SERVICE INFORMATION BULLETIN

APPLICABILITY: 2019-22MY Crosstrek

NUMBER: 18-225-24

SUBJECT: DTC B145C Heat Pump ECU Communication /
Service Manual Correction

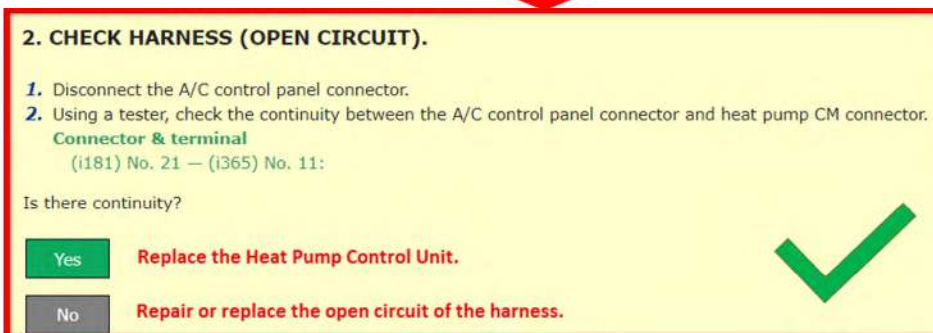
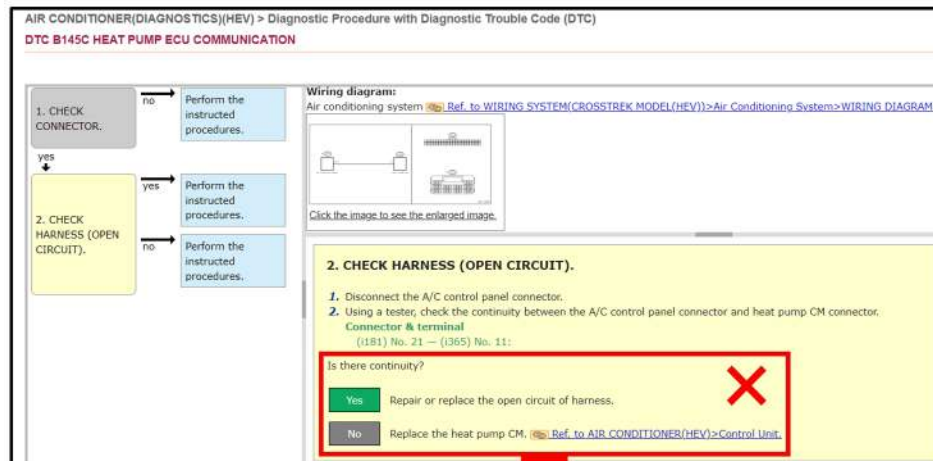
This Service Information Bulletin announces the diagnostic procedures to be followed when diagnosing DTC B145C (Heat Pump ECU Communication). The current procedure for DTC B145C is incorrect. Use the information outlined in this bulletin when diagnosing DTB B145C.

The current diagnostic information has the reverse workflow. Listed below, is a section of the current Service Manual with the corrections outlined in RED. This information will be added to the Service Manual in the future. This information is to be used in conjunction with the current Service Manual.
